Amendments to the Drawings:

REMARKS

FIG. 1

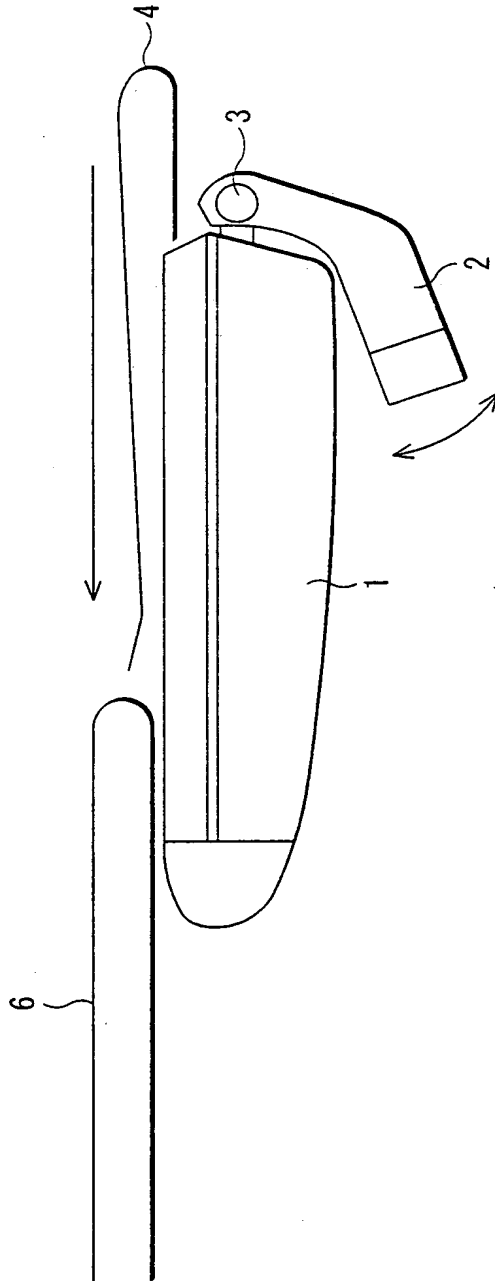
The specific changes which have been made to Figures 1 and 2 are to label these Figures as "PRIOR ART".

The drawings were objected to. Specifically, the Office Action indicated that Figures 1 and 2 should be designated by a legend such as --Prior Art--. Figures 1 and 2 have been amended to label them as "PRIOR ART". Accordingly, applicants submit that the objection has been overcome.

PRIOR ART
